DESIGN REVIEW BOARD MARCH 20, 2020

ALPHARETTA CITY HALL
COUNCIL CHAMBERS
2 PARK PLAZA
8:30 AM

- VII. PUBLIC HEARING
 1. 09:10 - 09:30 North Point Eco Guidelines
Kathi to discuss North Point Guidelines
 2. 09:30 - 09:40 DRB200011 SP&G Attorneys 284 North Main St
review signage

3. 09:40 - 10:10 DRB190054 The Felix School 500 Arts Summit
review exterior revisions
 4. 10:10 - 11:00 DRB190028 Lazy Dog 10800 Haynes Bridge
review new construction

DD4.4

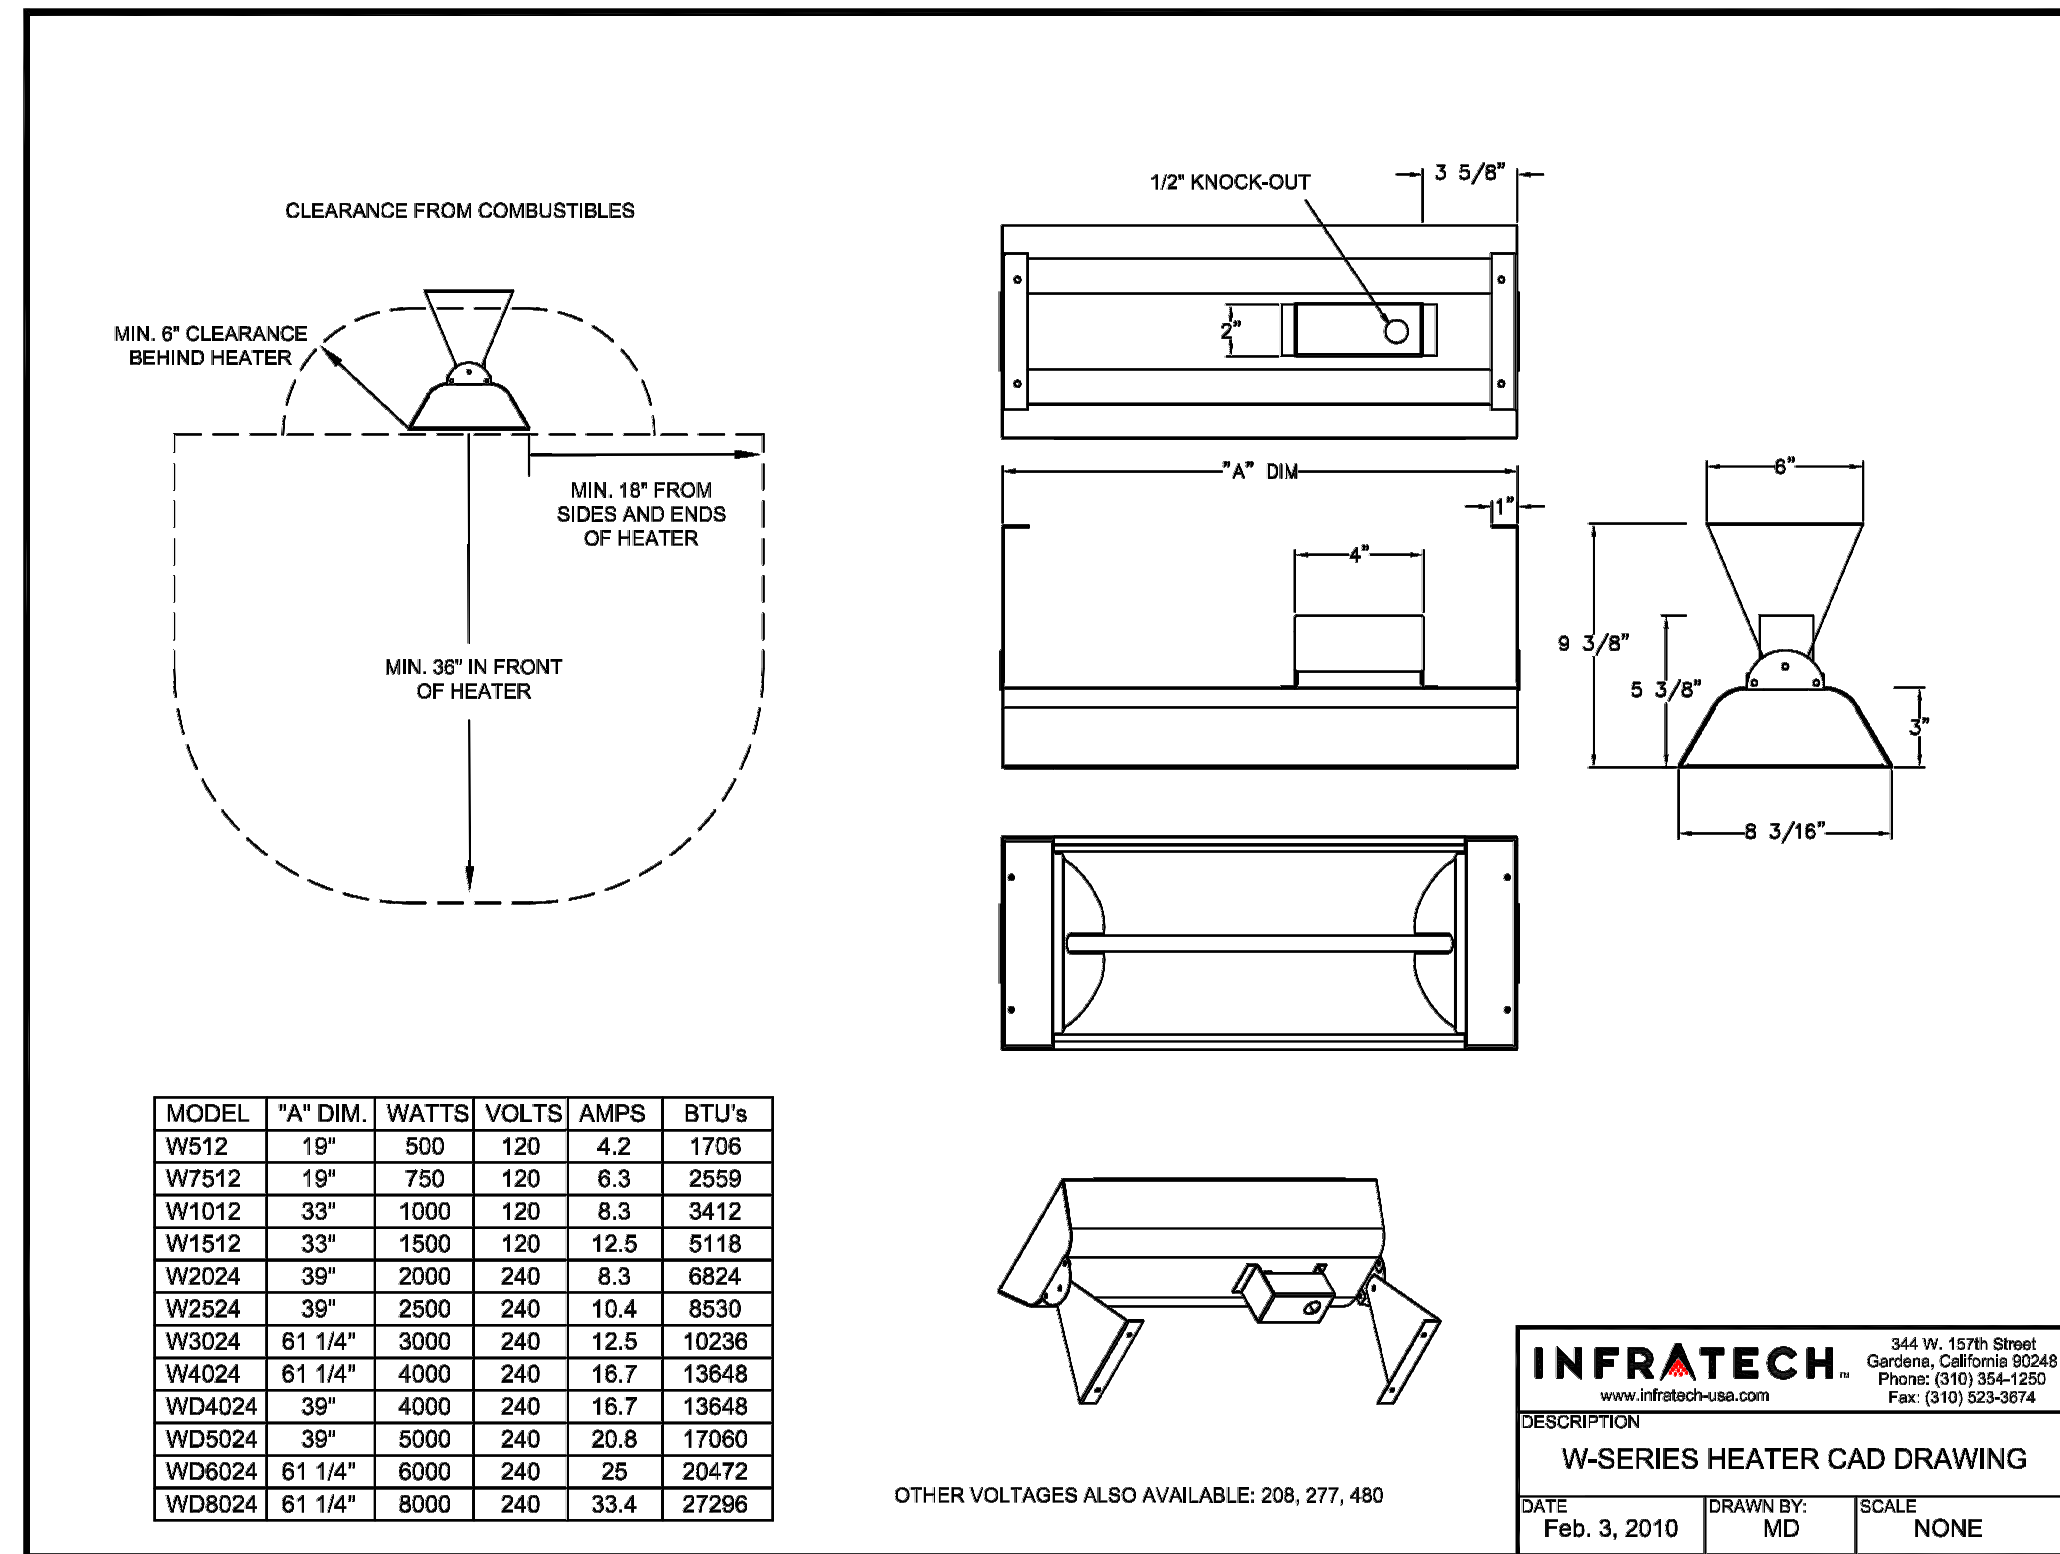
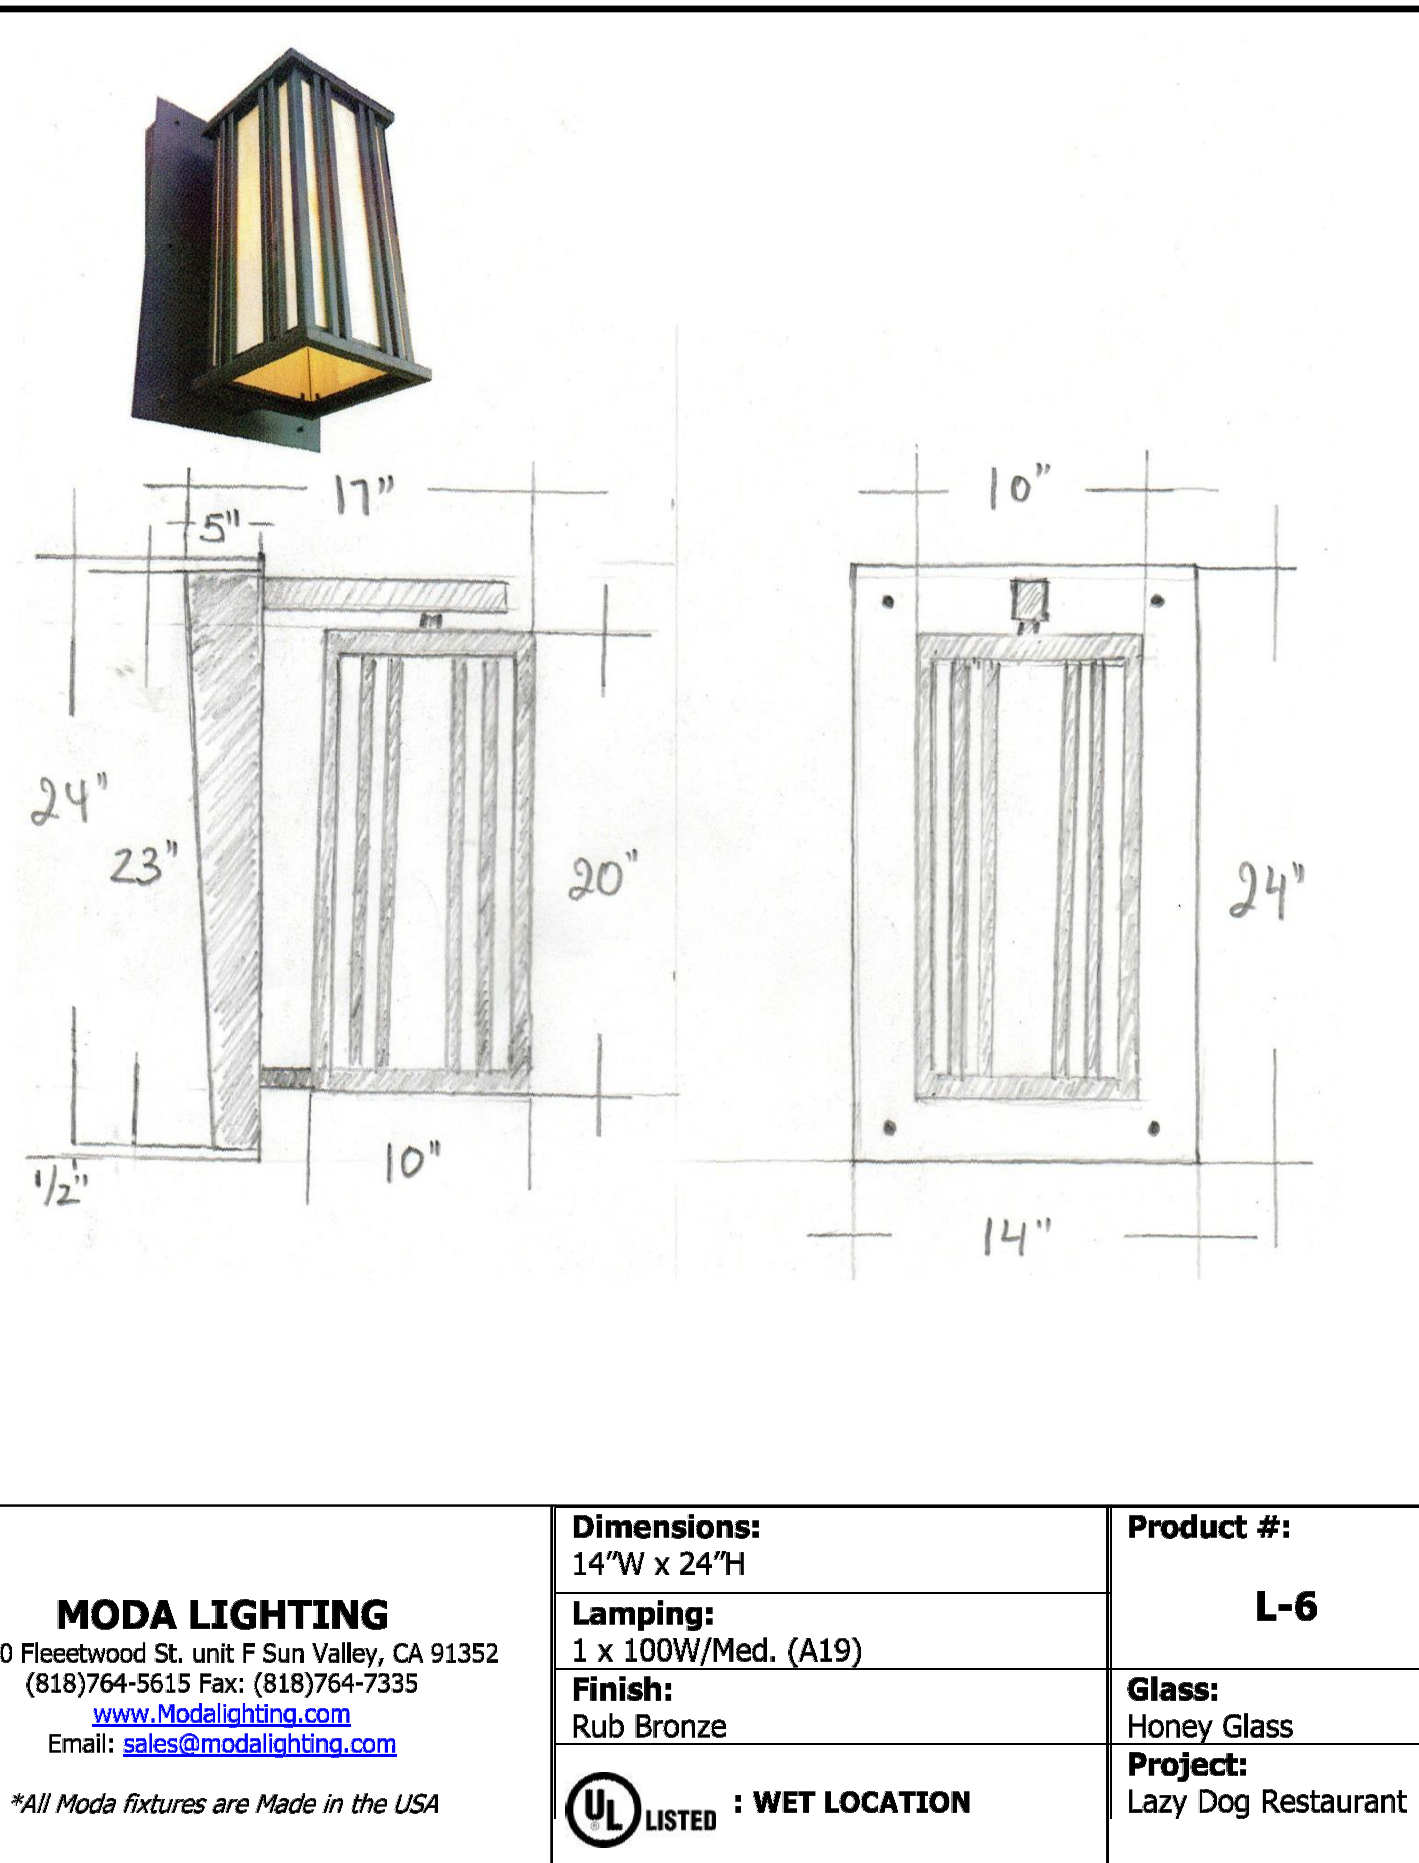
6. Any lights, fans, heaters, etc on the patios must be shown and detailed – See sheet DD4.4
7. Exterior light fixtures not shown in detail – See sheet DD4.4 for cut sheets

- Added sheet to set to show patio lighting, fans, heaters and building sconce cut sheets
